## REQUEST FOR COUNCIL ACTION

AGENDA SECTION: PUBLIC HEARINGS	ORIGINATING DEPT: PLANNING	ITEM NO. E-2
ITEM DESCRIPTION: Type III, Phase II Restricted Development #03-05, by Mayo Foundation. The applicant is requesting approval, through the Restricted Development process, for a pharmaceutical drive-up facility on the site. The property is located along the north side of East Circle Drive and west of Stonehedge Drive NE.		PREPARED BY: Mitzi A. Baker, Senior Planner

**RE:** Type II Conditional Use Permit and Type III, Phase II Restricted Development #03-05, by Mayo Foundation. The applicant is proposing a 51,000 square foot, 2-story family medical facility in the R-1 zoning district. The applicant is also requesting approval through the Restricted Development process a pharmaceutical drive-up facility on the site. The property is located along the north side of East Circle Drive and west of Stonehedge Drive NE.

The Department of Public Works has reviewed the application for Restricted Development Plan #03-05 for the Mayo Family Clinic Northeast proposal. The following are Public Works comments on this proposal:

SITE PLAN

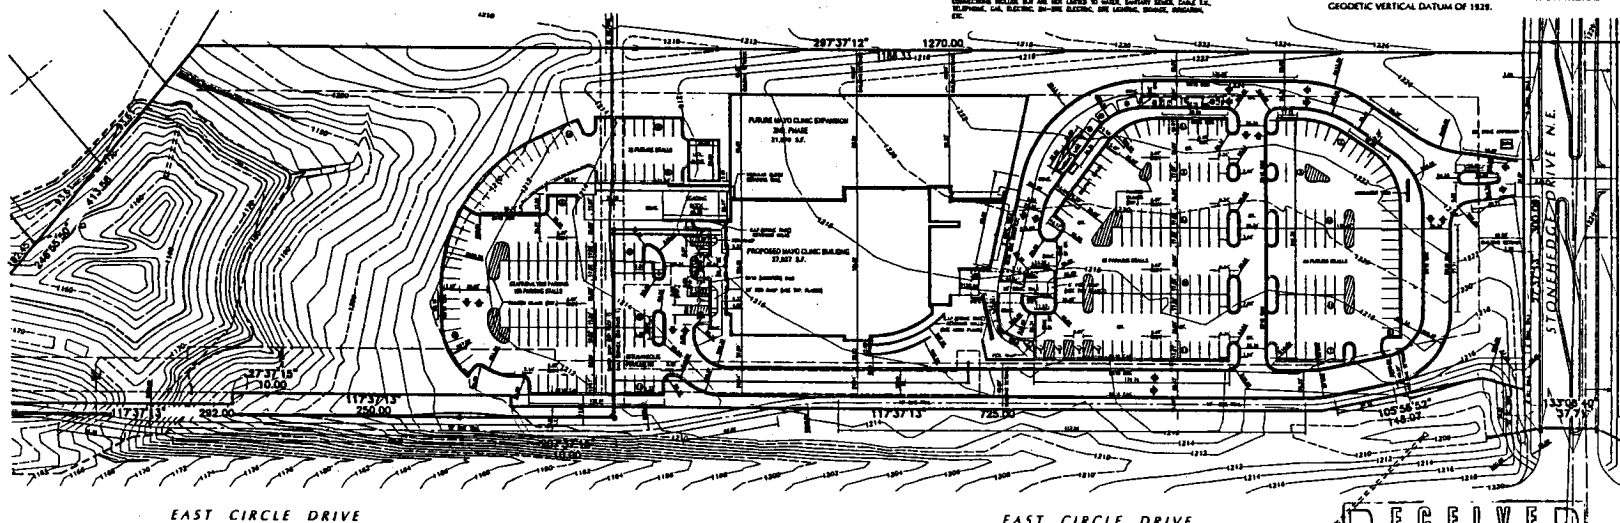
*The driveway access to this property is already in-place. Though construction plans were not approved at 34' width for the opening, it was constructed at 34 feet. Driveway width in excess of 32 feet requires approval by Council.*

6. ***There shall be a t minimum, a 2 foot wide separation between the bike path and the back of curb for the service drive.***
7. ***The proposed driveway exceeds the 32 foot maximum that is permitted without Council approval. If Council does not approved of the 34 foot wide driveway, the driveway design shall be modified to comply with the 32 foot limit.***

6. The proposed driveway exceeds the 32 foot maximum that is allowed, without Council approval.
7. There shall be at a minimum, a 2 foot wide separation between the bikepath and the back of curb for the service drive.

- 1. If the Council wishes to proceed, it should instruct the City Attorney to prepare a resolution either approving, approving with conditions, or denying this request based upon the criteria included in the staff report.***
- 2. The applicant request waiver of Final Plan per Section 60.532, 6 of the LDM. Staff recommends approval to waive Final Plan. Information being considered is sufficient to demonstrate compliance with applicable regulations and will not interfere with the purpose and intent of the Ordinance.***
- 3. Approve driveway access width at 34 feet.***
